BRACKNELL FOREST BOROUGH COUNCIL
PLANNING COMMITTEE
9th November 2023
SUPPLEMENTARY REPORT

Item No: 5

21/00592/FUL

Land South Of Forest Road Newell Green Warfield Bracknell Berkshire

Albren, Forest Rd

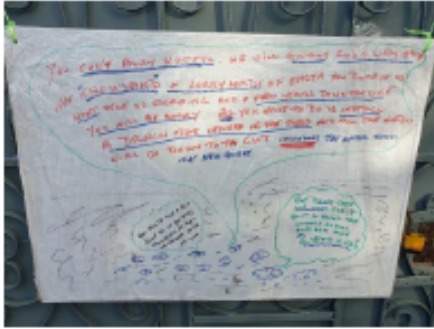
Water bubbling up from corner of old and newer fencing and running across the plot onto Forest Rd
